## THIS SERVICE BULLETIN OBSOLETES SB M20-160

**SUBJECT:** INSPECTION OF WIRE INSTALLATION AT STALL WARNING AND GEAR WARNING CIRCUIT BREAKERS.

**MODELS AFFECTED:** M20C, S/N 670001 thru 670123, S/N 670125 thru 670134, and S/N 670136 thru 670149.  
M20E, S/N 670001 thru 670062.

FIG. 1

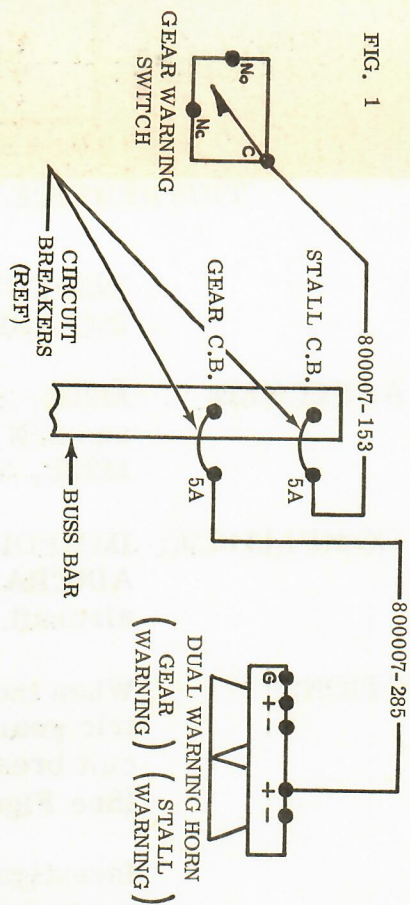
Investigation reveals that the wire connections may be reversed (See Figure 1 & 3.) at the stall warning horn and gear warning horn circuit breakers. Reversed wires at this location will make the stall warning horn inoperative on electric-gear equipped aircraft.

- 1) Inspect electric gear circuit breaker wire hookup. Reverse wire connections if hookup does not conform to the circuit illustrated in Figure 4.
- 2) Inspect manual gear circuit breaker wire hookup. Reverse wire connections if hookup does not conform to the circuit illustrated in Figure 2.

FIG. 4

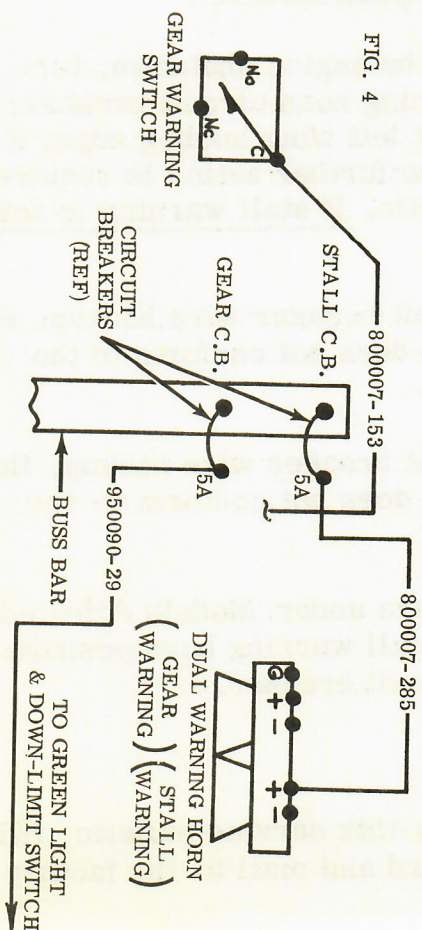
**INTRODUCTION:** When the standard manual gear is converted to the electric gear, wire number 800007-153 behind the main circuit breaker panel is to be left disconnected.  
(See Figure 4.)

**NOTE:** On all aircraft listed above under Models Affected, wire No. 800007-285 must run from stall warning horn positive connection to stall warning horn circuit breaker.
